**PLANNED UNIT DEVELOPMENT  
& SUBDIVISION STAFF REPORT****Date: October 3, 2013****DEVELOPMENT NAME**

Providence Park Subdivision, POB West, North Addition

Planned Unit Development Approval to amend the conditions of a previously approved Planned Unit Development to allow the expansion of lots and parking area, and Subdivision approval to create 3 lots.

# SITE PLAN

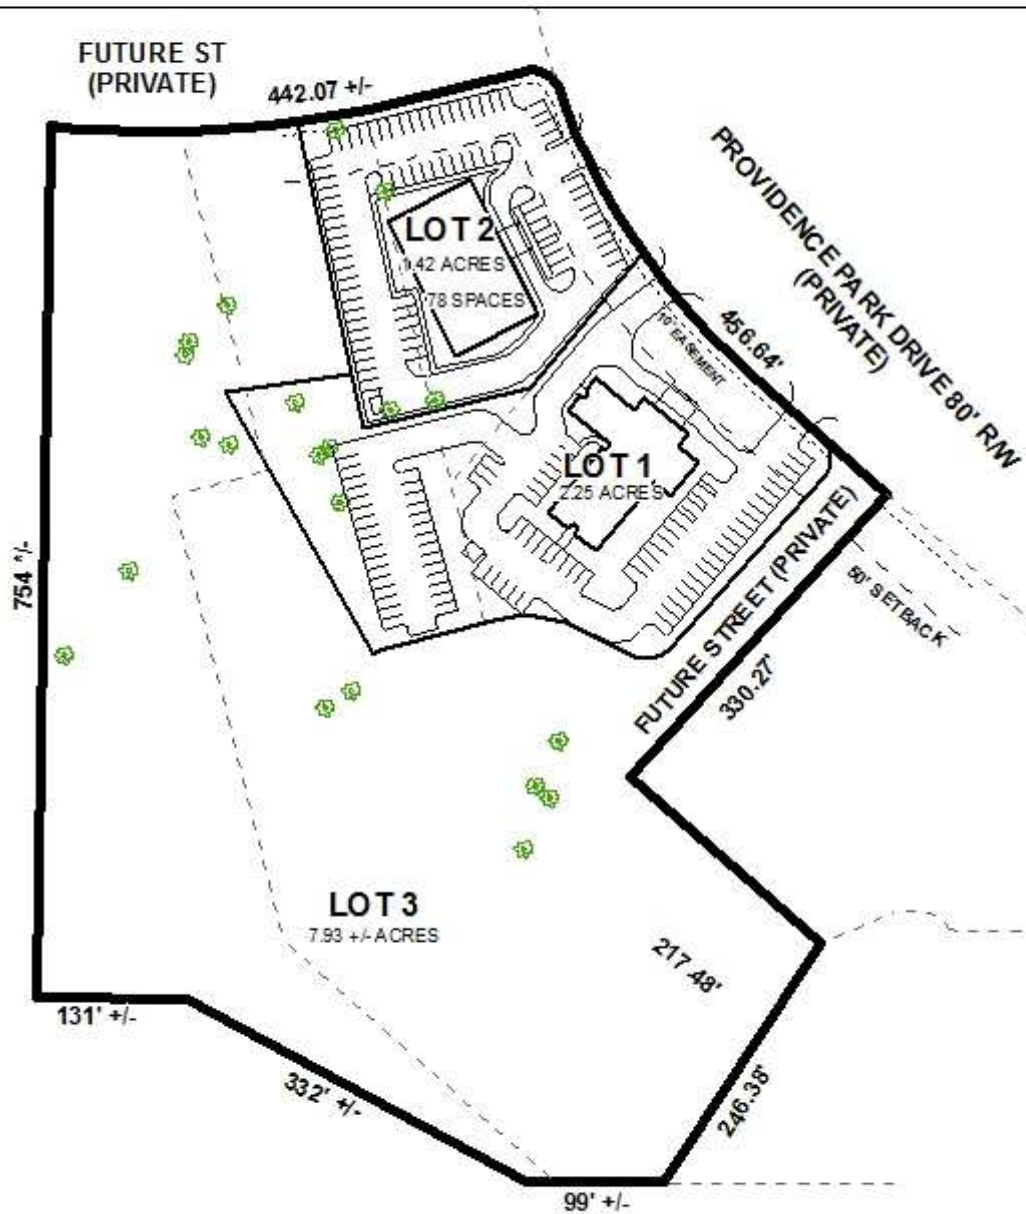
The size of existing and proposed parking spaces is not depicted on the site plan, but it should be noted that all parking spaces must be a minimum of 9 x 18 feet, and that any accessible parking spaces required by the applicable building code regulations include the appropriate signage, markings and access aisles.

The site plans for Lot 1 and 2 depict curb-cuts to Providence Park Drive East. Lot 1 has two existing curb-cuts, as per previous approvals, and the development proposed on Lot 2 depicts one curb-cut to Providence Park Drive East. As PUD approval is site plan specific, Lots 1 and 2 should be limited to the curb-cuts as depicted. Lot 3, not currently slated for development, should be limited to one curb-cut to Providence Park Drive East. The size, design and location of any new curb-cuts, or modification to existing curb-cuts, are to be approved by Traffic Engineering, and to conform to AASHTO standards. The curb-cut limitations should also be noted on the preliminary plat, if approved.

It should be pointed out that sidewalks, existing or proposed, are not depicted on the site plan. The site plan should be revised to depict existing and proposed sidewalks along Providence Park Drive East.

The preliminary plat and the PUD site plan depict the lot sizes in acres but not in square feet. Both should be revised to also include the lot size in square feet.

The preliminary plat and the PUD site plan depict a 50-foot minimum building setback line along Providence Park Drive East for Lots 1 and 2, but no setback line is depicted for Lot 3 where it is a minimum of 60-feet in width, nor are setback lines depicted for Lot 1 where it abuts a proposed future street, whereas a setback is proposed for Lot 2 where it abuts a future proposed

street. Both the plat and site plan should be revised to show setbacks for all proposed lots, along all existing or proposed streets. A note on the plat states that there are 25-foot minimum setbacks, which conflicts with what is depicted.

- 1) Revision of the site plan to depict and label setbacks from all existing and proposed streets for all three lots, where the lots are a minimum of 60-feet in width;

- 2) Revision of the site plan to also include the lot size in square feet;
- 3) Revision of the site plan to depict existing and proposed sidewalks along Providence Park Drive East;
